Our Ref: 80221001: L010A v05 GN
Contact: Garry Neville

Breen Resources

BREEN RESOURCE RECOVERY FACILITY – RESPONSE TO AGENCY COMMENTS

Figure 1: Pedestrian (red) and RRF Vehicular (blue) traffic interaction

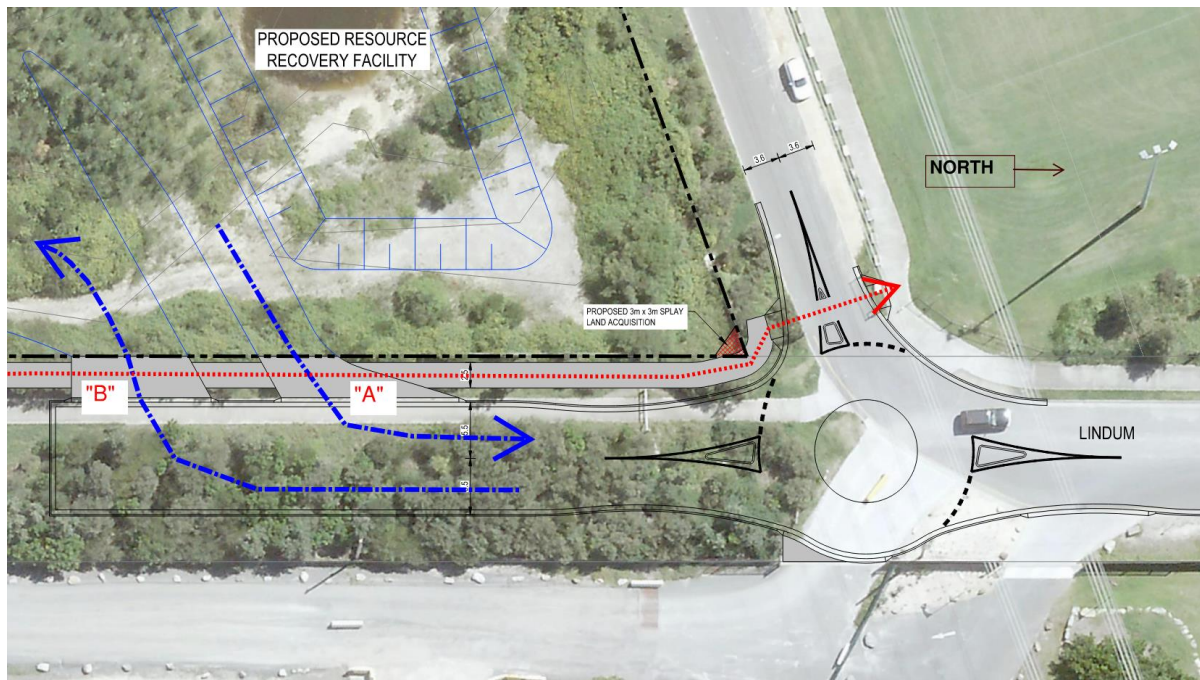
Agency Comment: *Round about alignment. A detailed design for the site access with Lindum Road considering other existing accessways and pedestrian facilities must be provided. An assessment of the potential conflicts with traffic to and from the recreational areas and cars parked on Lindum Road should also be provided.*

The primary pedestrian movement at the location of the proposed intersection is from the existing Lindum Road path to/from the beach access track adjacent to the RRF's eastern boundary as shown in red on **Figure 1**.

In the existing situation pedestrians are required to cross two lanes of traffic in the single movement at a bend on Lindum Road.

This proposed intersection improves the safety of this movement as the roundabout configuration presents an opportunity to introduce a pedestrian island at the western leg of the intersection, thereby reducing the pedestrian movement to a single lane crossing at a time. Sightlines for pedestrians to oncoming traffic are also improved with the inclusion of a roundabout at Lindum Road, particularly for pedestrians heading south across Lindum Road as the turn speeds of vehicles is slowed due to much reduced turn radius. The configuration of the roundabout also aids pedestrians to anticipate traffic heading south on Lindum Road by improving visibility and sight lines.

The separation of the entry and exit lanes provides for a de-facto pedestrian refuge island, enabling pedestrians to anticipate one vehicle direction at a time. These are marked as points "A" and "B" on **Figure 1** and are the exit and entry point to the Facility respectively. Sightlines for traffic exiting will be maintained as part of the final design and site features such as landscaping and entry statements will be designed to ensure sightlines are not compromised.

Table 1-3 Weekday Daily Volumes

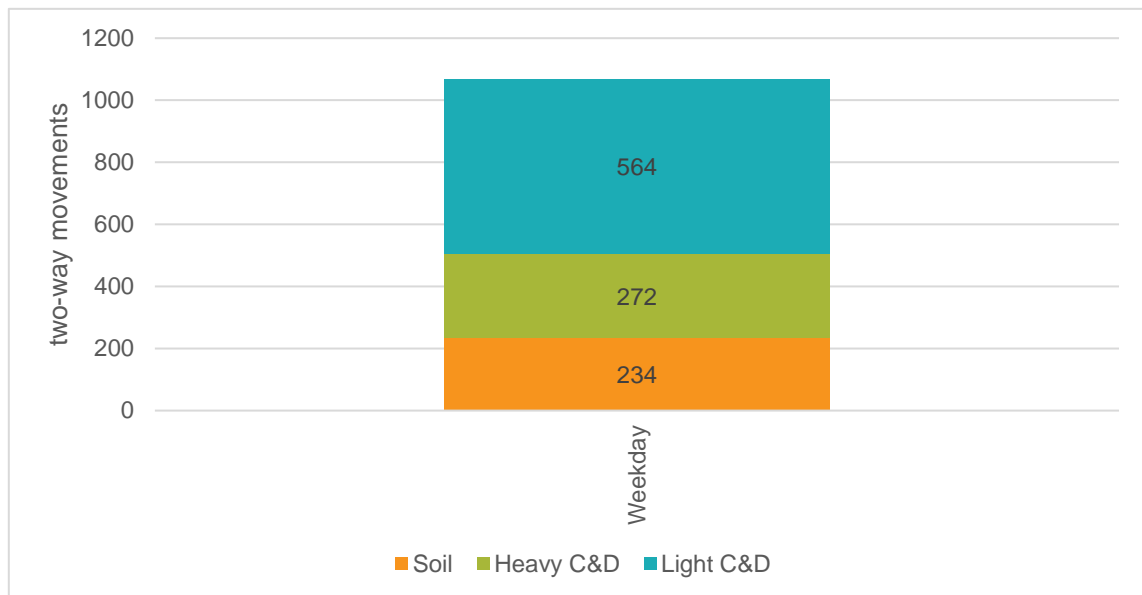
Agency Comment: *The Traffic and Transport Report does not illustrate how the forecast daily traffic movements of 1,070 two-way vehicles on weekdays was calculated, including breaking this down by heavy vehicle type. It is requested the proponent illustrate how the forecast daily traffic movements of 1,070 two-way vehicles on weekdays was calculated, including breaking this down by heavy vehicle type. This should show how the forecast vehicle daily movement figure is capable of moving the 650,000t intake and 600,000t export to and from the site.*

The resulting number of average daily movements by material type (accounting for vehicle types) is shown in the figure below.

Figure 7-2 Sediment and Erosion Control Layout

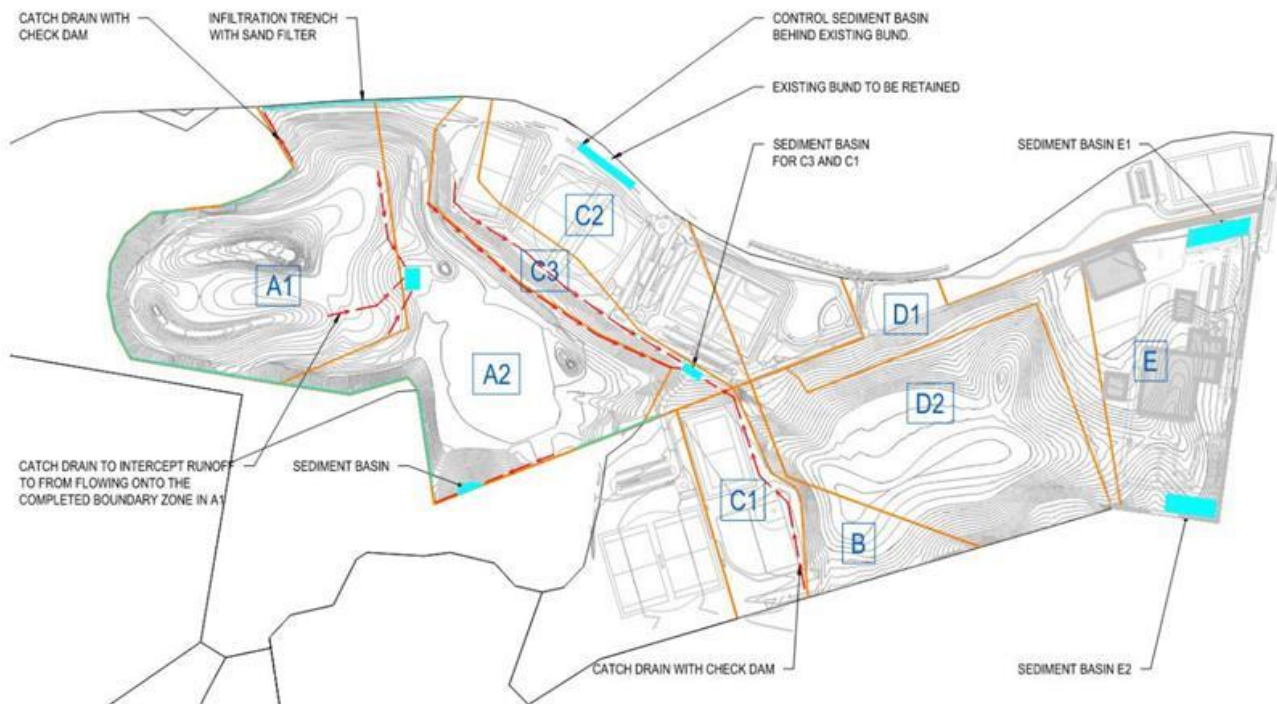
Agency Comment: *The Proposal proposes erosion and sediment controls designed consistent with Managing Urban Stormwater: Soils and construction – Vol 2B, waste landfills (DECC 2008). The SWIA indicates that two sediment basins would be utilised during construction. However, no details are provided of the location, design storm capacity and the expected frequency, volume and quality of discharges. The SWIA states that the sediment basins will be finalised at detailed design.*

Response: The information requested above was submitted with the original EIS in Appendix H. Table 5.3 and 5.4. Locations are shown in Fig 7.2. These figures have been include below for ease of reference.

Drawing 80218082-SK005 Lindum Road Concept Roundabout layout – Turn Paths.

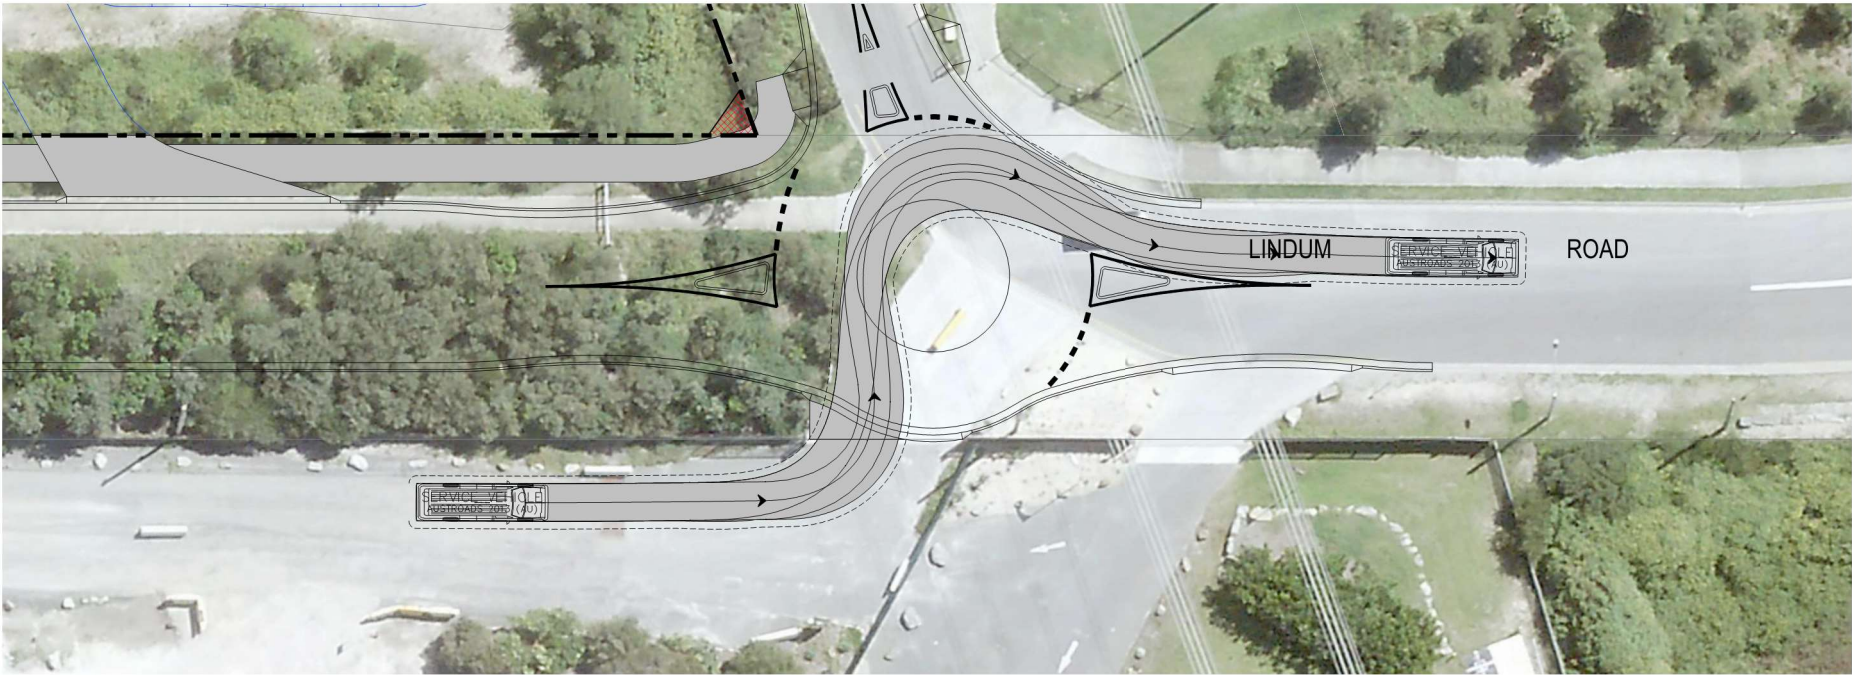
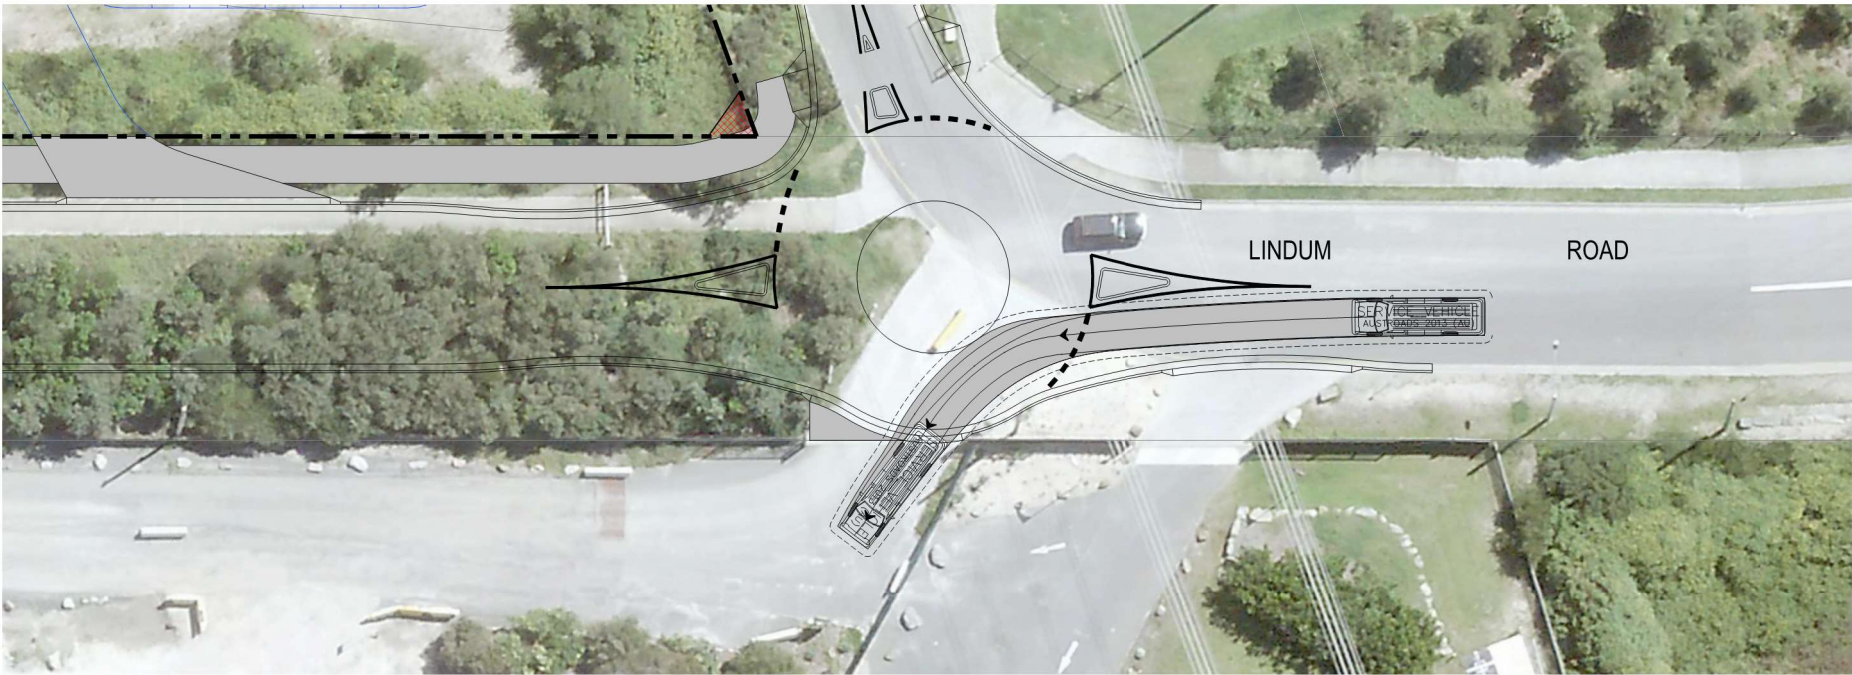
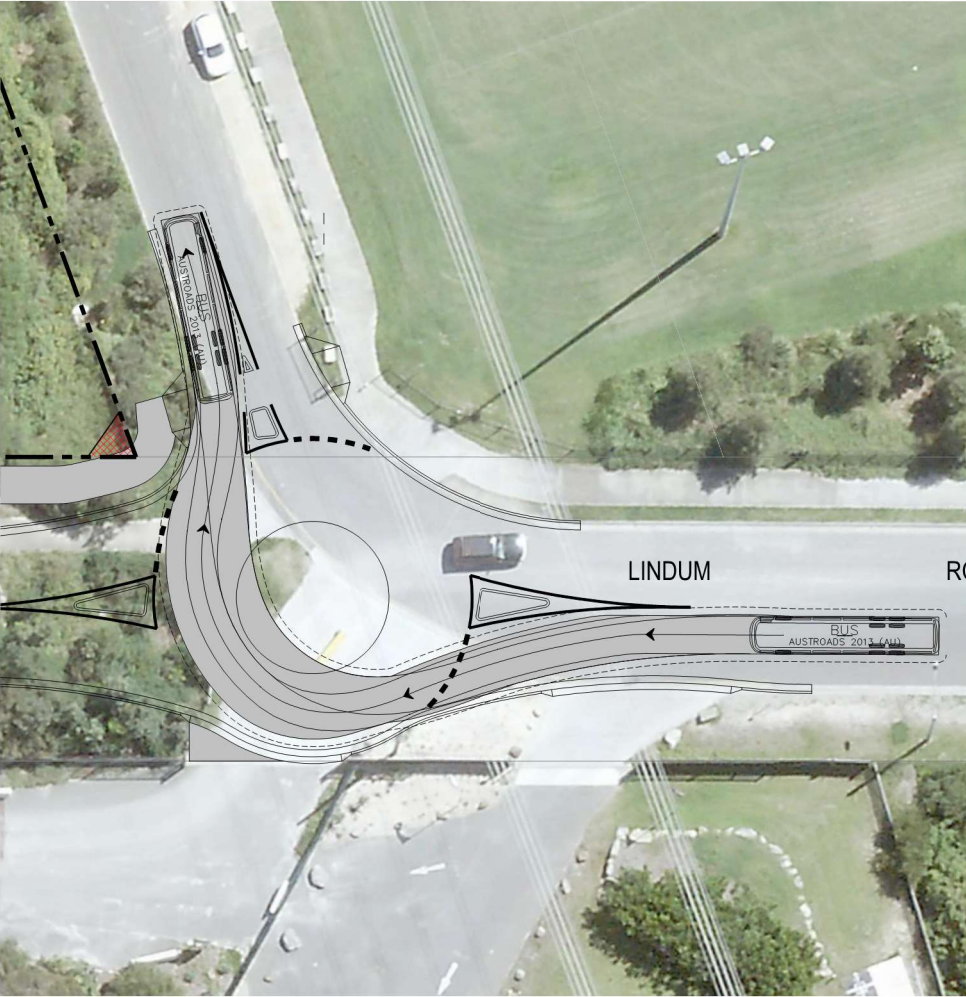
Besmaw Comment: *Detailed Civil Engineering plans showing the internal car and truck parking, road dimensions, long and cross sections have not been provided. This includes the new entry point connecting to Lindum Road. To understand the operation of this access point and the likely future conflicts further detailed information must be provided on how it will be constructed.*

Besmaw Comment: A swept path analysis has not been provided to determine if in-going and outgoing trucks can bypass one another without resulting in a loss of on street carparking.

Response: The design of the proposed roundabout on Lindum Road at the RRF driveway was designed in conjunction with Sutherland Shire Council's Senior Traffic Engineer and is attached to

this submission. Vehicle turning paths have been attached to this response to demonstrate operation of this access point.
